Addendum No. 1

Bid Opportunity: 7159-RW-22 – Smithson PS Office and HVAC Upgrades.

Closing Date: Monday, March 14th, 2022 2:00 PM

4 EXIST./DEMO POWER PLAN - CUST./STAFF WC/OFFICE
E3 SCALE: 1:50

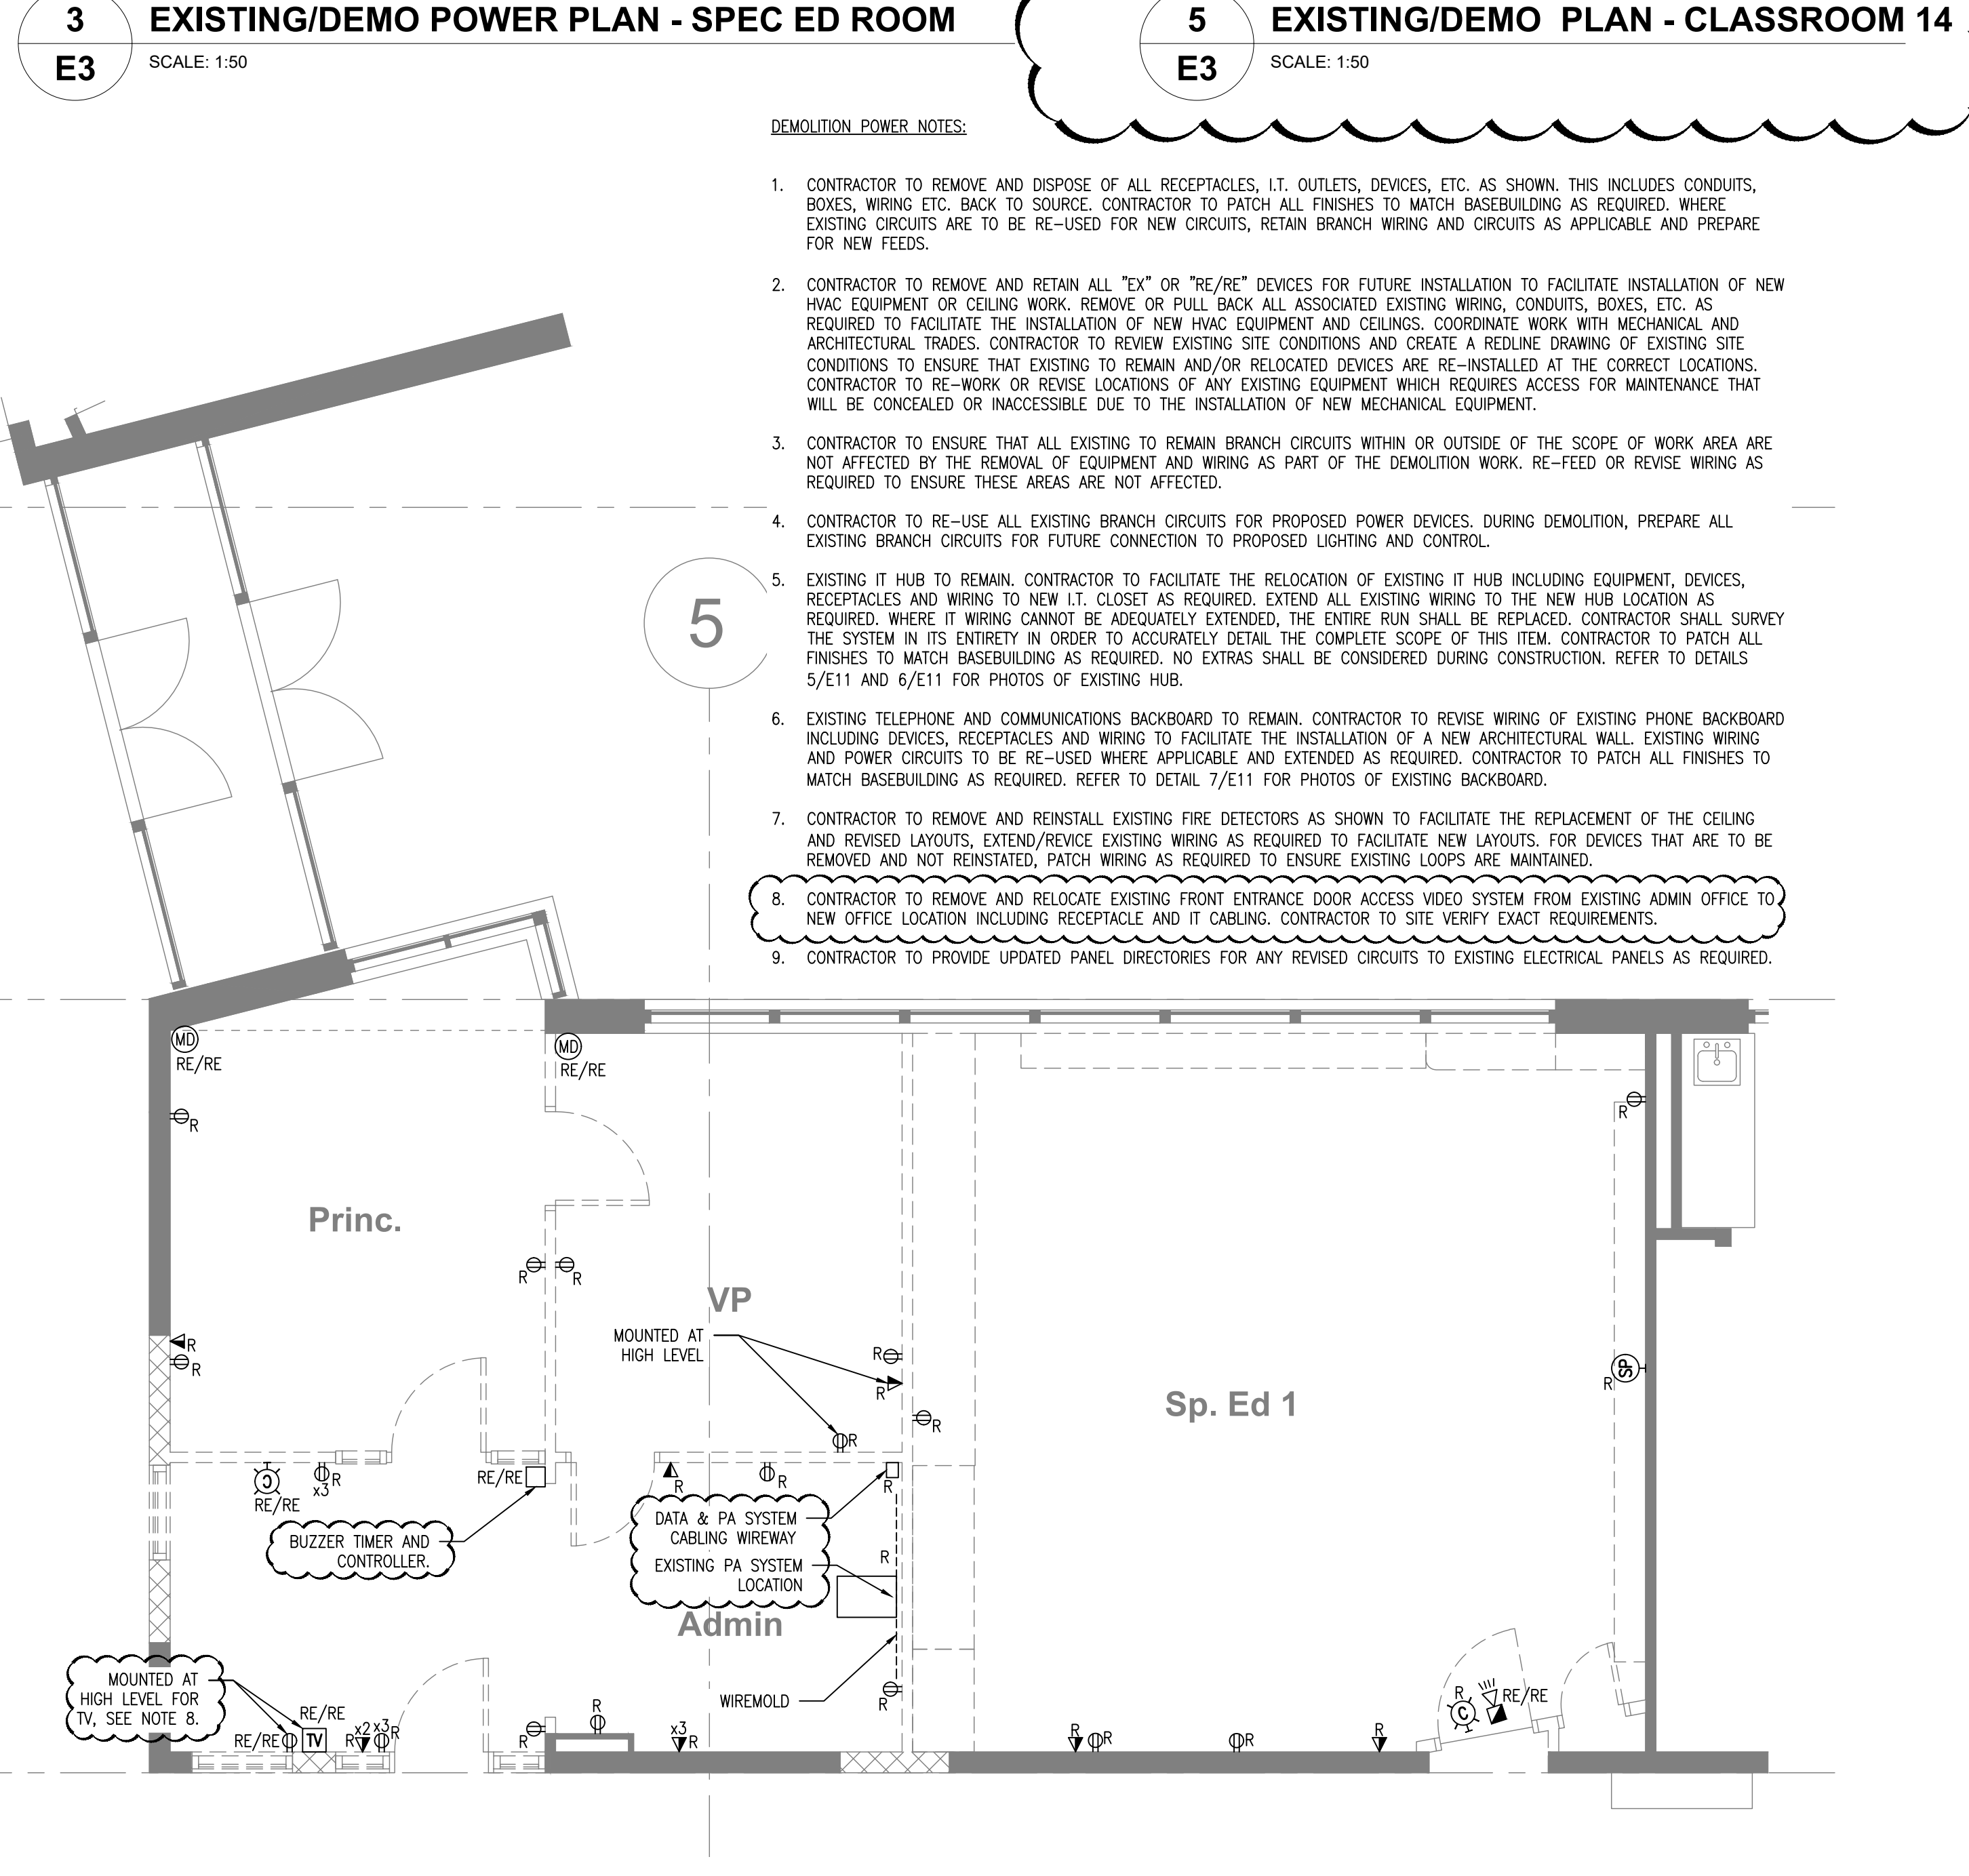
2. Within the existing office space detail 4/E3, a device labelled as “TIMING SWITCH AND TIMER/CONTACTOR” which is to be removed and relocated, has been clarified to “BUZZER TIMER AND CONTROL”. This device shall be removed and relocated as shown on layout drawings to facilitate the architectural changes within the office. Revise and/or extend wiring as required to facilitate the relocation.

3. Notes on detail 4/E3 regarding the existing door access video system have been revised. The existing TV receptacle and IT terminals shall be removed and relocated as shown on layout drawings to facilitate the architectural changes within the office. Revise and/or extend wiring as required to facilitate the relocation.

4. The location of the existing PA system and wireways have been noted on detail 4/E3. The new location of the PA system is shown on the proposed layout drawings. The contractor shall revise and/or extend wiring as required to facilitate the relocation, refer to detail 3/E6 for more information.

Drawn By DB Scale As Shown
 Designed By DB Date November 26, 2020
 Project Number **B20-349.02A**
 Sheet Number Revision
E6 **1**

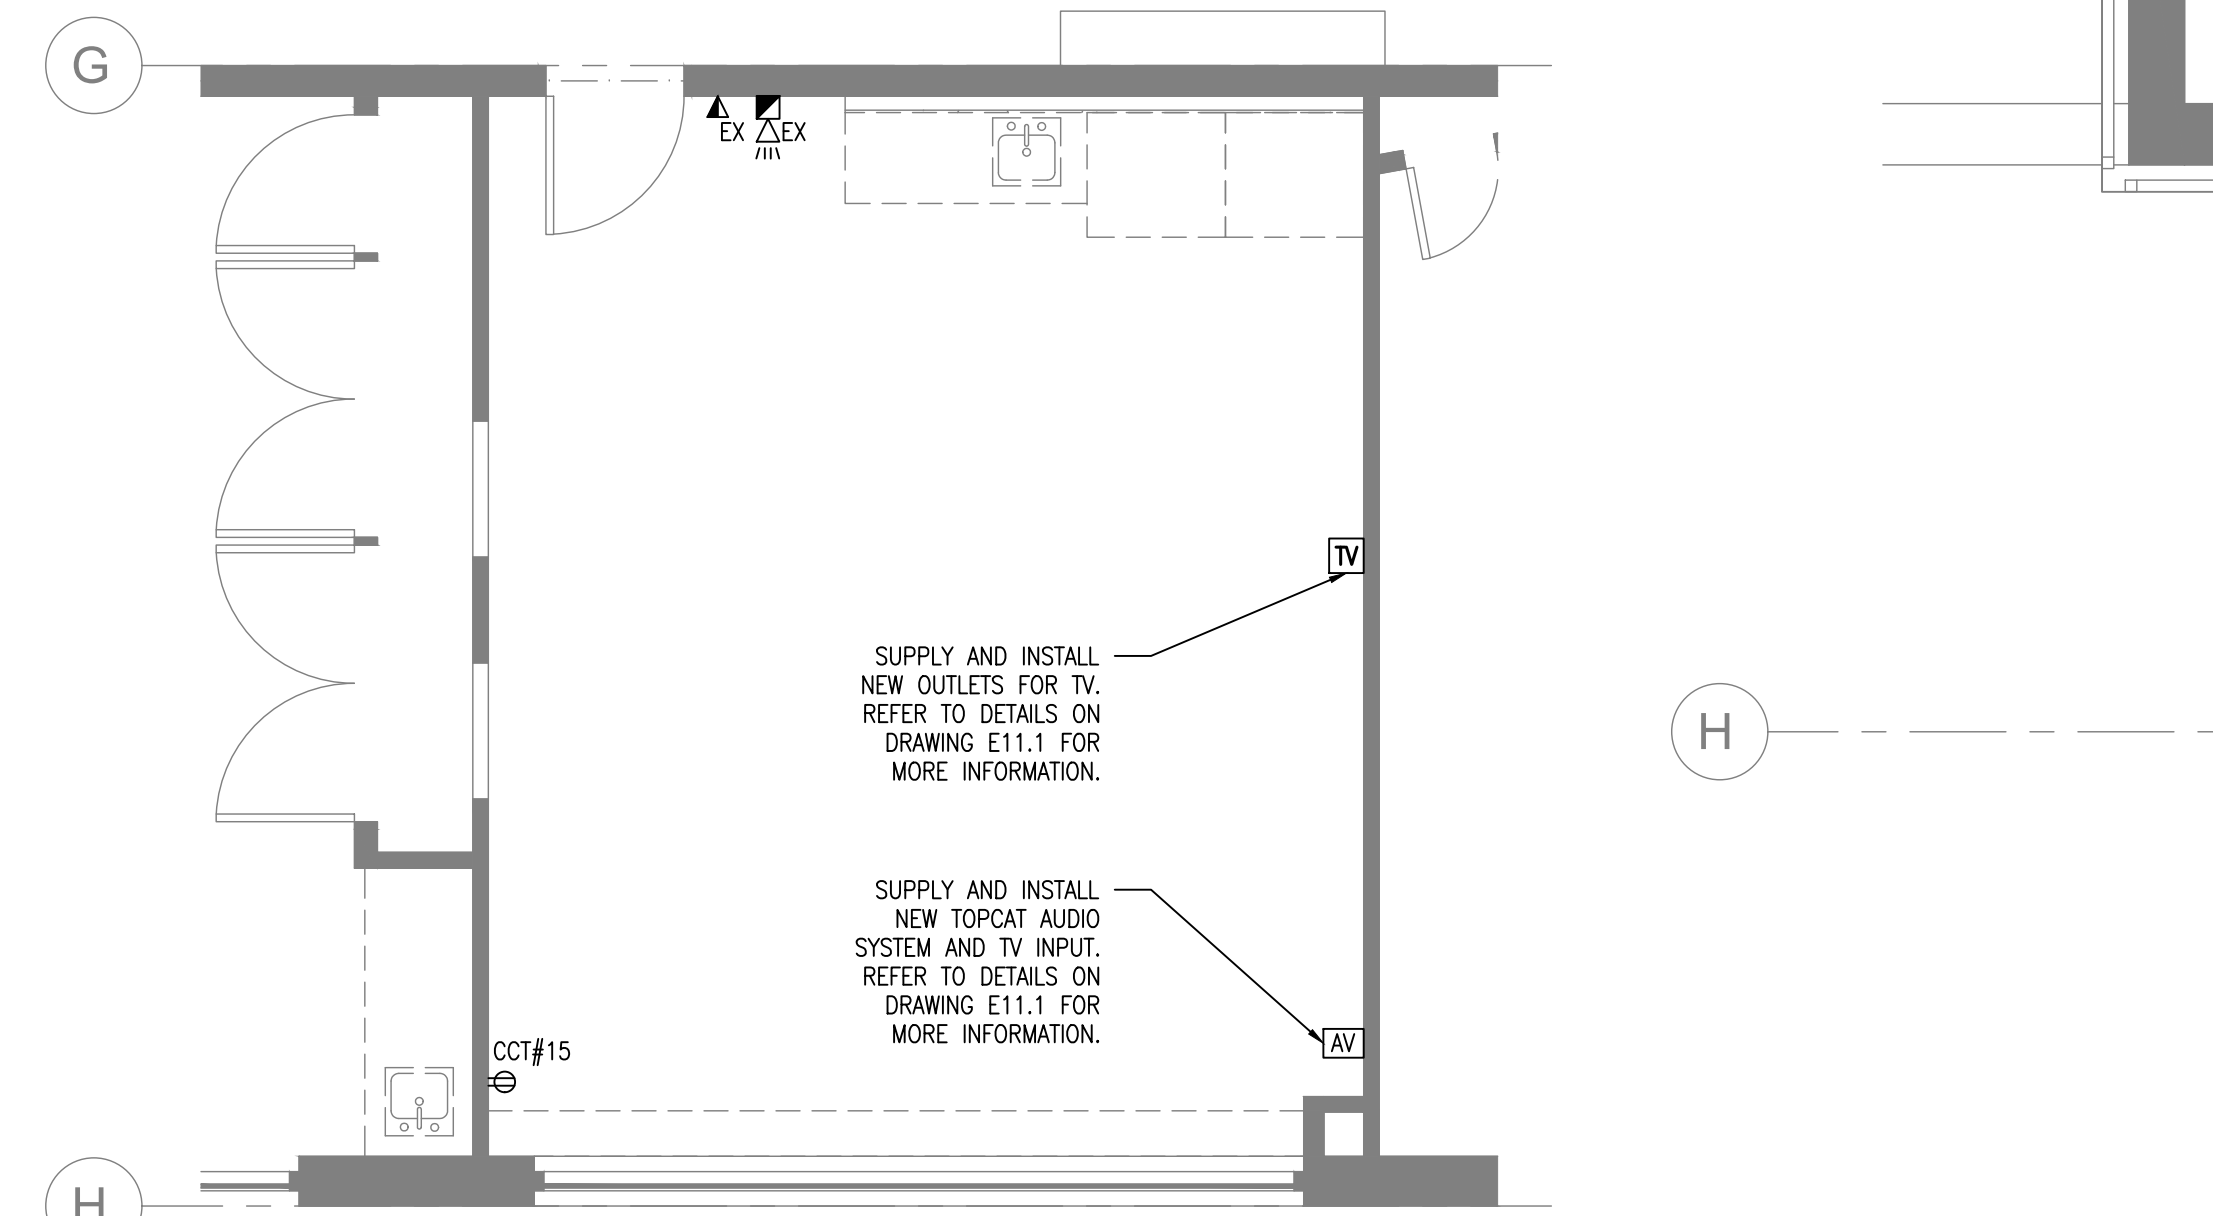
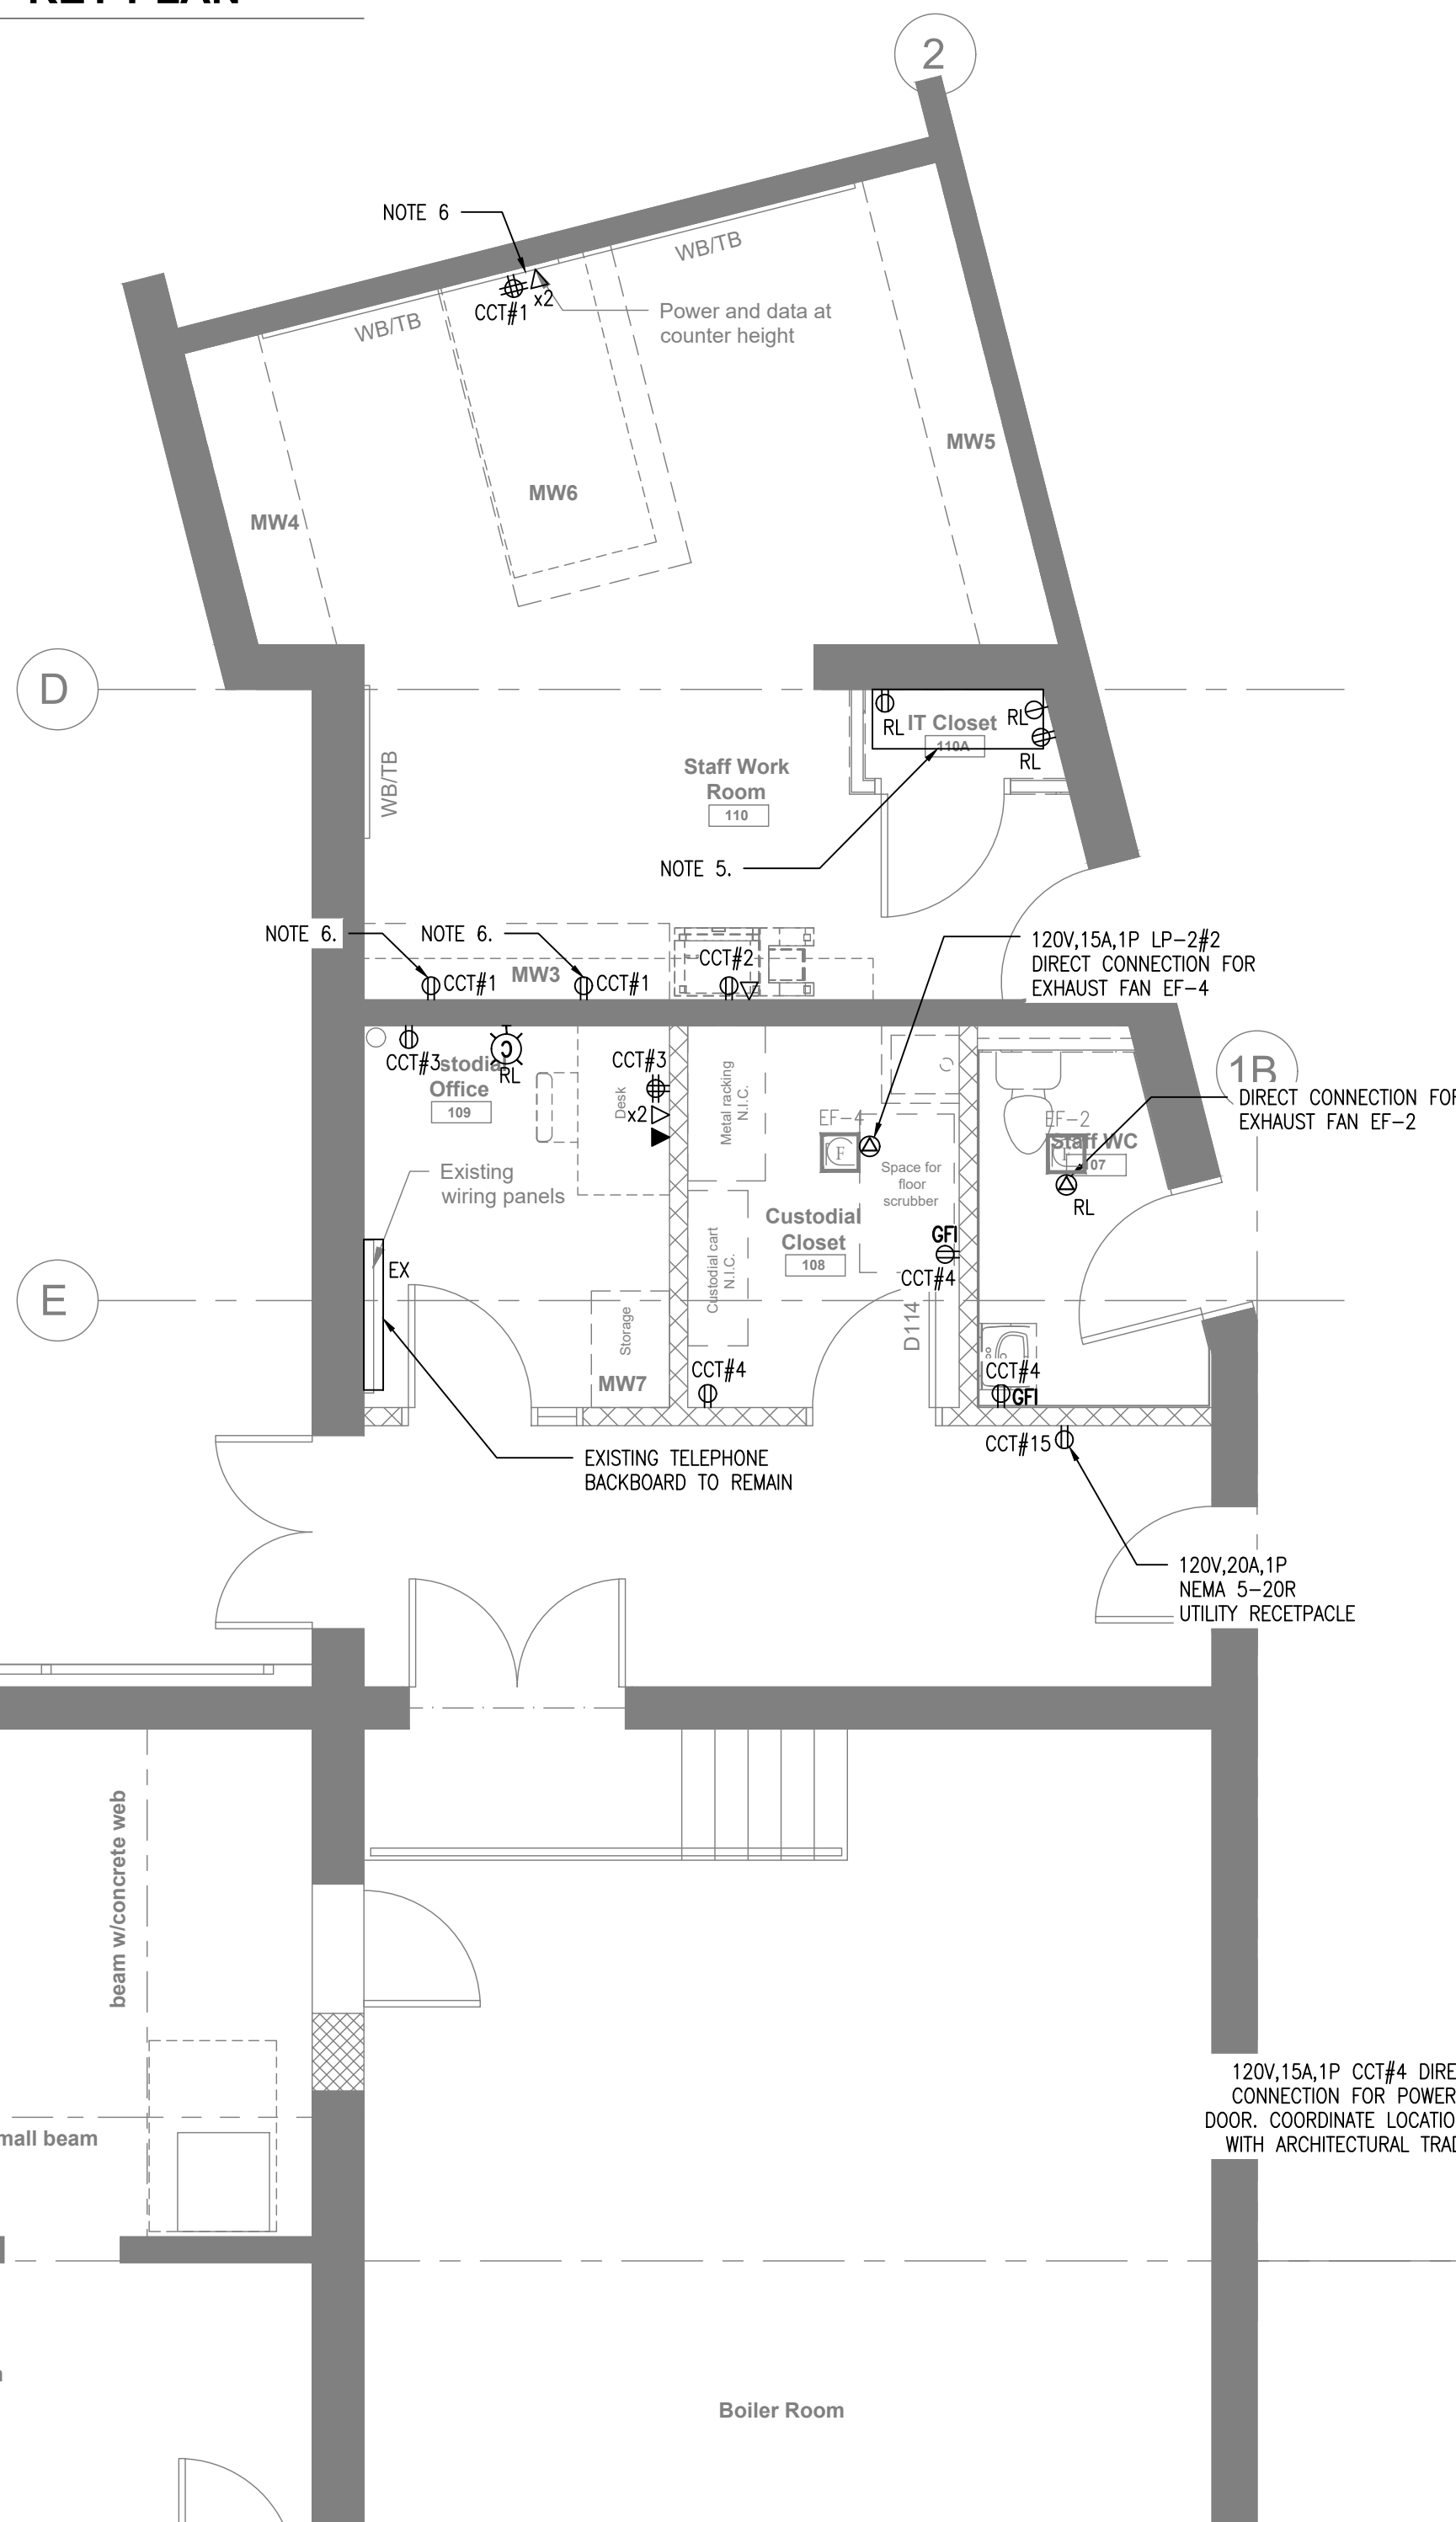
5. REFERENCE DRAWING E6 – PROPOSED POWER PLANS (ISSUED FOR ADD-E01)

1. Note 8 on drawing E6 has been revised to provide further information regarding the power and IT cabling to be provided at each furniture whip. Each furniture whip shall have 1xPower, 2x Data, and 1xPhone terminations. Confirm termination requirements will millwork and architectural trades.
2. Within the existing office space detail 3/E6, a device labelled as “TIMING SWITCH AND TIMER/CONTACTOR” which has been relocated, has been clarified to “BUZZER TIMER AND CONTROL”. This device shall be relocated as shown on layout drawings to facilitate the architectural changes within the office. Revise and/or extend wiring as required to facilitate the relocation.
